Proof of Evidence

of Simon Cairns

Colchester Borough Council S.78 Appeal Against Non-Determination concerning

LPA Ref: 190647

The appeal Scheme with annotations (see paras 6.11 – 6.29 below)

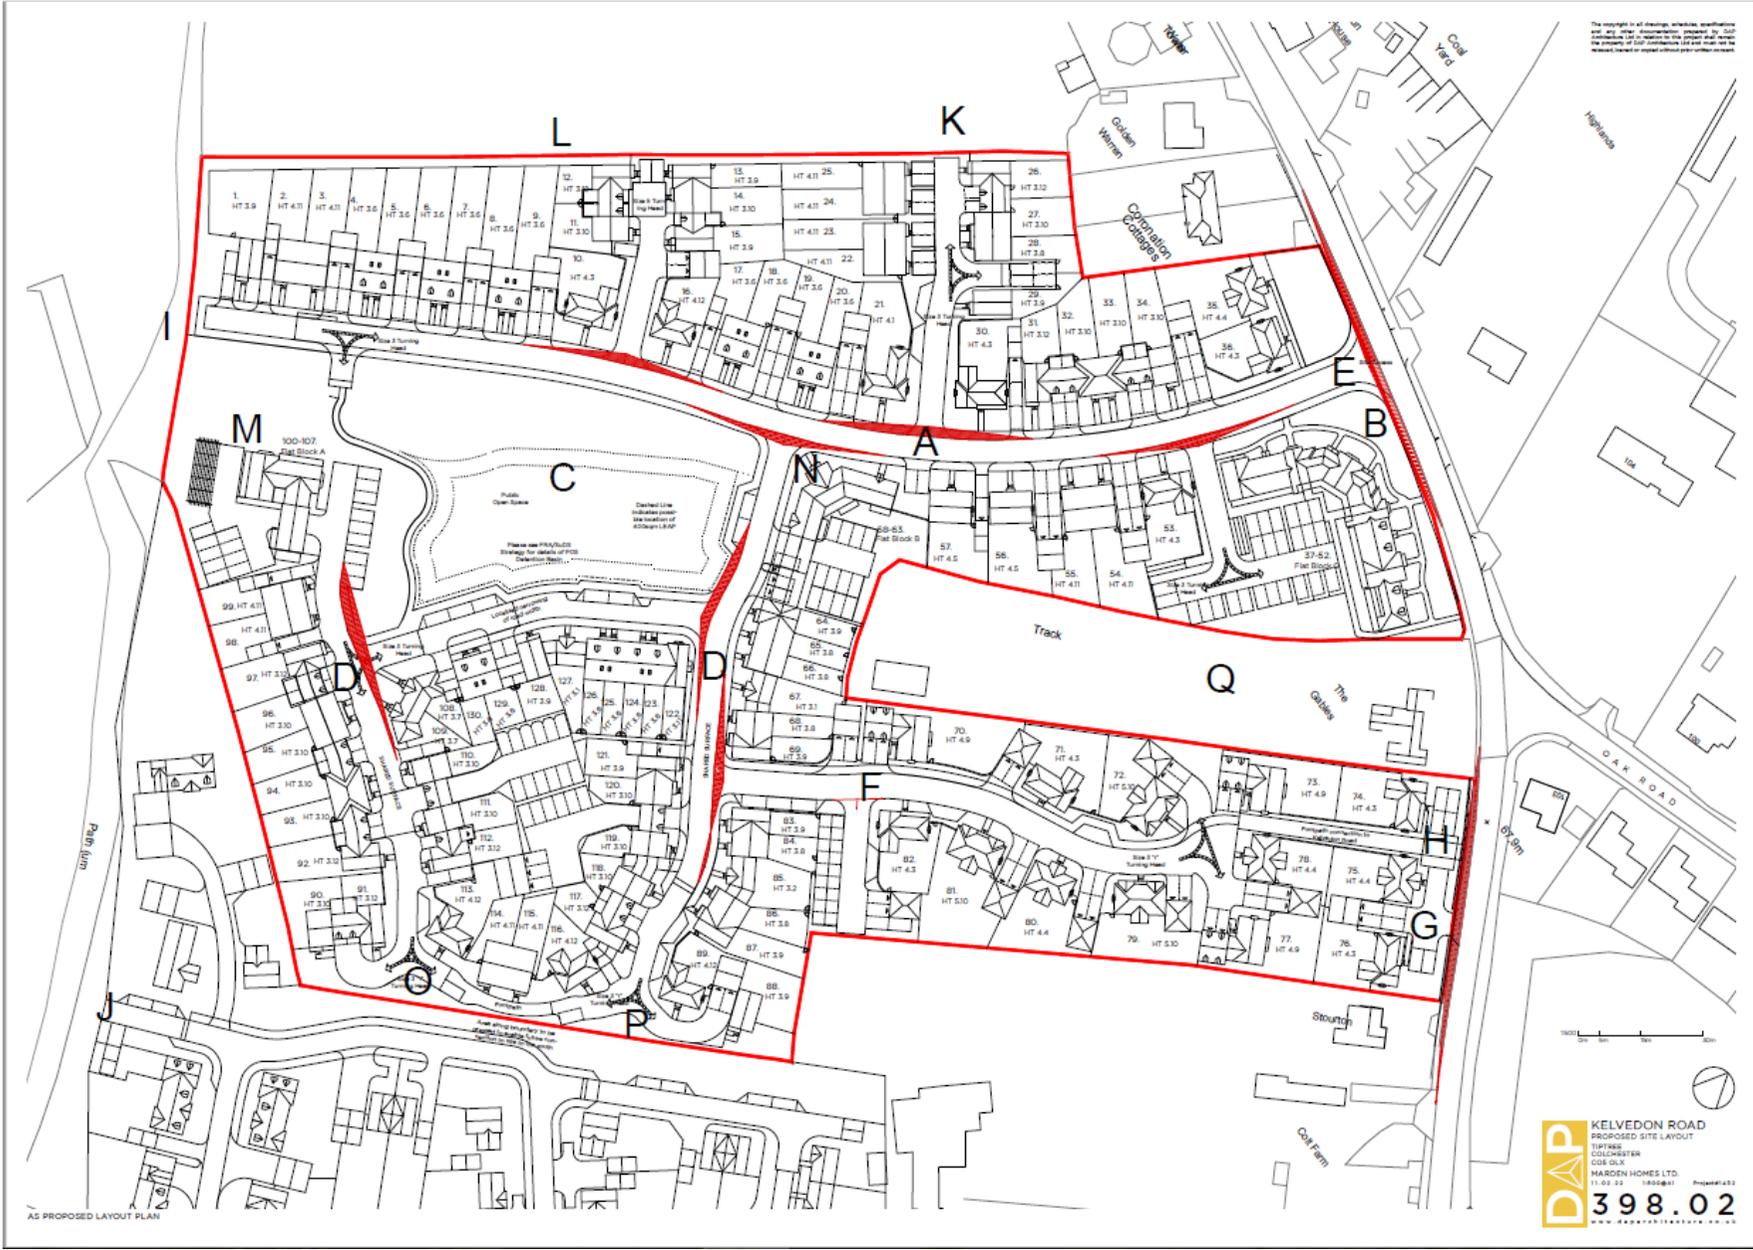
- 6.11** The appeal scheme (drawing 1432.301.01 Layout) comprises (by reference to annotations on layout plan above)
- A) a main street aligned NNE-SSW with twin short cul de sacs running northwards and terminating against the northern site boundary. This main street terminates against the site's southern boundary and does not provide onward connectivity with the adjacent footpath;

6.15 The appeal scheme varies in height between two and three storeys (Storey Heights Plan 302.00). The continuous frontage to the south of the main access includes 3 storey development on the southeast corner of the access (B) together with Flat Block A rising to three storeys at the south west corner of the site (M) abutting countryside and the sole POS I do not believe this to be contextually appropriate within an edge of settlement location. Furthermore, Tiptree is characterised by modestly scaled built forms of generally one or two storeys (with the exception of its notable windmills and the adjacent water tower!). Flat Block A is over scaled (M) for the proposed development on the edge of the site abutting countryside (three storey plus pitched roof) and apart from the East Elevation is unattractive and overtly suburban in character. Flat Block C (N) occupies a key corner site location adjoining the principal access point. The proposed tall three storey corner focal point would appear wholly out of context on the edge of a rural settlement on the important northern approach from Kelvedon. The built form is also complex and contrived and wholly alien to the simplicity of the surrounding settlement character in my judgement. The rear of the block is reminiscent to an American motel with continuous externalized balconies. (See also Appendix 4)

6.16 The character and place of the appeal scheme is rooted in local distinctiveness but is a bland anodyne suburban housing estate with no particular references to the locality nor indeed the rich vernacular traditions of north Essex generally. The house types suffer from excessive plan depths (e.g. 336.01, 312.01 or 313.01) and car parking is sometimes contained in rear parking courts that lack passive surveillance (e.g. rear of units 119-212) or excessively dominant in the streetscene (e.g. Plots 22-29) Views along streets are not closed by attractive built form but simply terminate rudely against the site boundary (adjacent plot 1 or 25/26) or indeed parking plots (plots 12-13) (I & K). This is poor and reinforces the lack of connectivity between the site and its immediate environs.

6.17 There is a single area of POS adjacent to Flat Block A (M) containing a planned LEAP. The lack of a hierarchy of spaces distributed throughout the site results in a rather dated and monotonous character to the scheme with streets dominated by built form and lacking spatial interest. With the exception of this solitary POS, residents have no informal spaces to sit and linger or for social interaction or pet walking and incidental exercise on or off lead apart from the access visibility splays or the land within the turning head at the southern ends of the cul de sacs adjoining plots 91/13 and 89/116 (O & P). (See also Appendix 4)

6.21 Furthermore, the approach taken to SUDS which proposes that the sole dedicated area of POSLEAP (C) functions as the detention basin for the entire site (drawing 2229/RE/01/REVA – FRA and Surface Water Drainage/SUDS Strategy, July 2021) renders this area of occasional wetland of very limited ecological value due to the inevitably intensive use of the POS by residents. This feature will not substitute for the loss of the existing pond at the heart of the site which is currently in a tranquil location where wildlife is undisturbed. The loss of a water feature in a water stressed county is a considerable loss of habitat within a scheme that fails to make provision for ecology. This green infrastructure is surrounded by development that forms a barrier to migration in the absence of a corridor to natural habitat. Such a fragmented approach is unacceptable. (See also Appendix 4)

6.23 The scheme proposes an intensively used single area of POS located at the western end of the site (C). This sole area of POS is overlooked by development and would be safe for use. However, the LEAP could discourage senior adult use for tranquil reflection as the POS will be inherently dominated by play for children and highly animated as the only off lead area for dog owners. Furthermore, as the SUDS retention basin forms most of the rest of the open space, it is questionable how usable the area will be during the winter months and summer periods of intense rainfall. In my judgement, the space may not be usable at all times and by all parts of the community and represents inadequate provision to be inclusive for all of the community's needs and to serve the development as a whole. (See also Appendix 4)

Figure 7.4 Left to right: (a) the buildings and urban edge of a street help to form the place; (b) the kerb line can be used to reinforce this; and (c) the remaining carriageway space is tracked for movement and for the provision of places where people may park their vehicles.

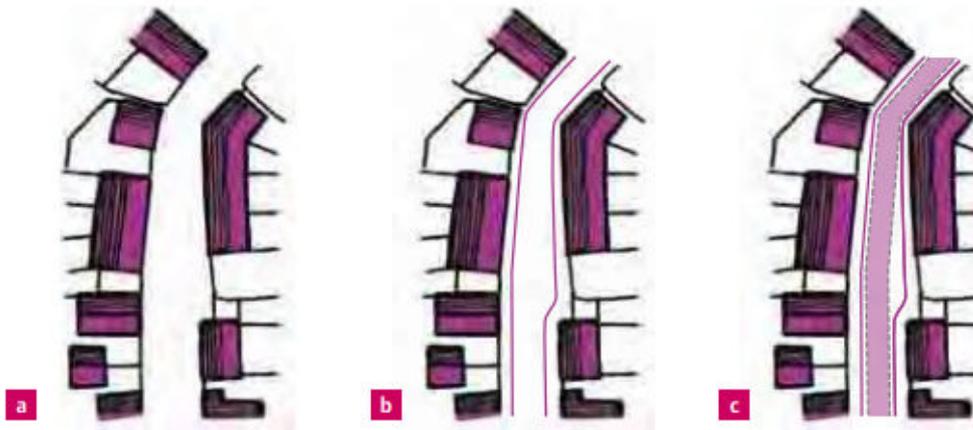
The proposed link road to allow for future potential connections is overly prominent and poorly terminated given the lack of any wider master plan beyond the site boundary. Accommodating connections to potential future sites should be achieved in a less dominant manner or interim arrangement should be proposed. Beyond this the proposed road layout appears acceptable in terms of its positioning and the majority of prominent vistas and corners are treated in a relatively appropriate manner. However, the below vista should be amended in order that it is not terminated by the rear parking court and structure on the below corner should be amended to turn the corner more appropriately.

Additionally, the road layout as proposed appears overly engineered. This should be rectified by following the principles of tracking (as identified by 'Manual for Streets').
